Splicer X-Package Upgrade

Splicer X Upgrade Application

Splicer drive side before upgrade

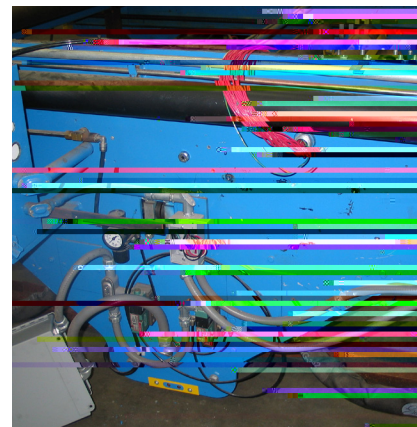
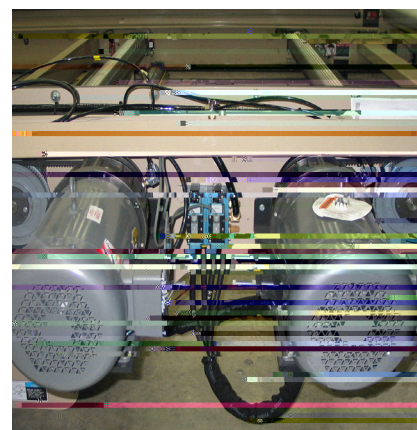
- Features additional high HP capstan roll and motor, and larger capstan motor for existing capstan roll.
- New hardware:
 - After removal of the existing components, the new roll, motors, pulleys, belts and guards are installed. Motors will be wired to control cabinet.
 - Control cabinet will be updated with necessary controls and components.

- Increases the paper splice speed by 50 MPM (150 FPM)
